This the TCC (Tallaght Community Council) objection to the SD22A/0361 (final date for submissions Thurs 20 Oct 2022) . The application fee has been paid and the receipt is attached.

Development: Demolition of all existing 1-3 storey industrial/commercial structures and small cafe on site totalling c.5,500sq.m in area; Construction of a 1-5 storey Transitional Care Facility (step-up/step-down) providing 131 bedspaces over partial basement (total floor area c.6,743sq.m) with central courtyard (c.519sq.m); The basement consists of a sprinkler tank and pump rooms, water tank room, plant room and workshop; Provision of dining and kitchen areas, sitting/family rooms, activity rooms, coffee dock, hair salon, oratory, lobbies/reception areas, ancillary offices and staff areas, stores, toilets, shower/changing facilities, ESB substation, generator, switchroom, service yard and waste areas serving the facility; Lobbies, stair/lifts, photovoltaic panels and green roofs throughout; Partial provision of the pocket park identified in the Tallaght LAP (c.1,286sqm); New vehicular access from First Avenue and egress onto Cookstown Road via a one-way system through the subject site; Entrance signag

Figure 3 Approach to Belgard Luas Stop, you have to walk through private property

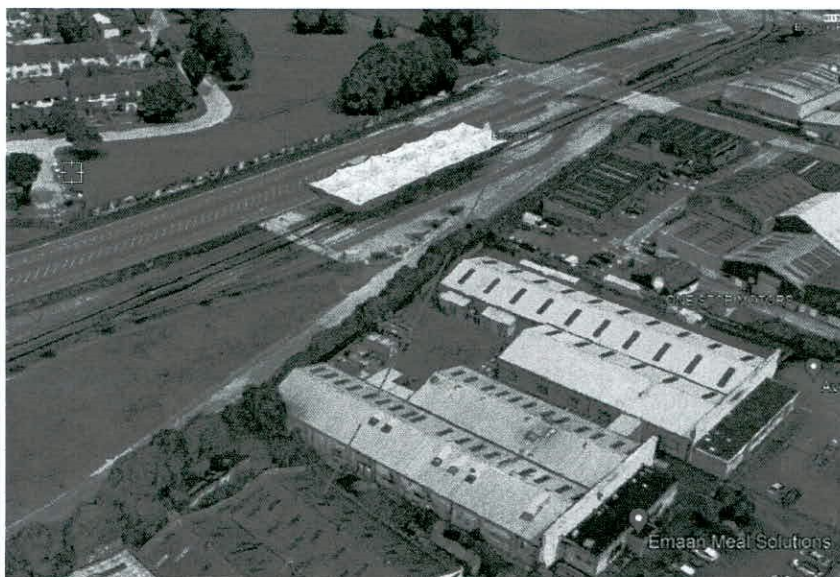
On Google Maps the distance as the crow flies to the Belgard Luas is 297 m. We as the count to check this figures, because of true then 297 m is not approximately 200 m. Also, the map shows there is clearly **no direct way of walking to the Belgard Luas**, so it is not very helpful to quote as “as the crow flies” when the map shows no direct path and indeed to even attempt a direct path would require crossing a Line which is dangerous

To go as the crow flies should require going through private property and a surrounding trees (see figure). This "200 meter as the crow flies figure" is misleading, and is certainly not a reason for giving planning permission,
